PRODUCT CHANGE NOTICE

1. TITLE IR RADHard™ Power MOSFET / R6 Performance Change	2. DOCUMENT NUMBER FV5-C-10-0003
	3. DATE February 11, 2010

IR Global Change for DC-SOA (for RH, R6, N-channel)

IR2N7580T1 (IRHMS67160)

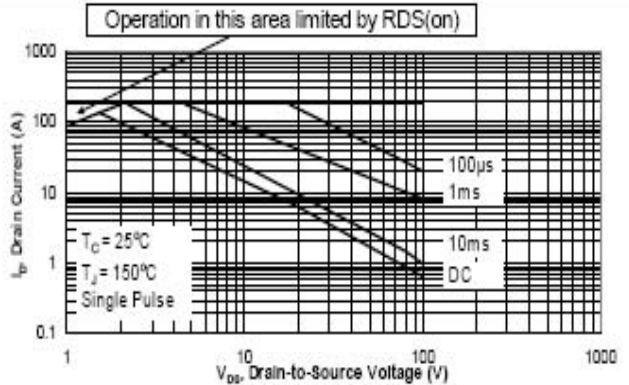
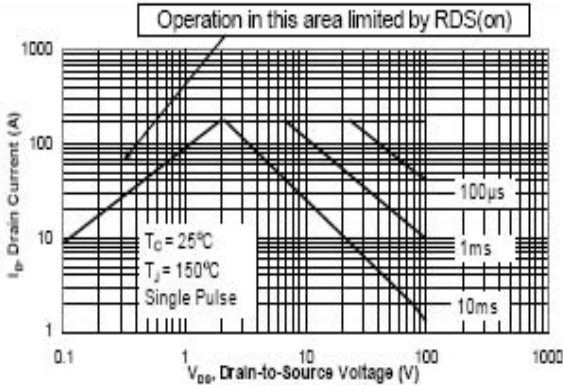
14. PRODUCT CHANGE
 This GIDEP PCN is to announce specification change / update for SOA (Safe Operating Area) on the following IR RADHard™ Power MOSFET products. Refer to Table 1 below for the affected part numbers.
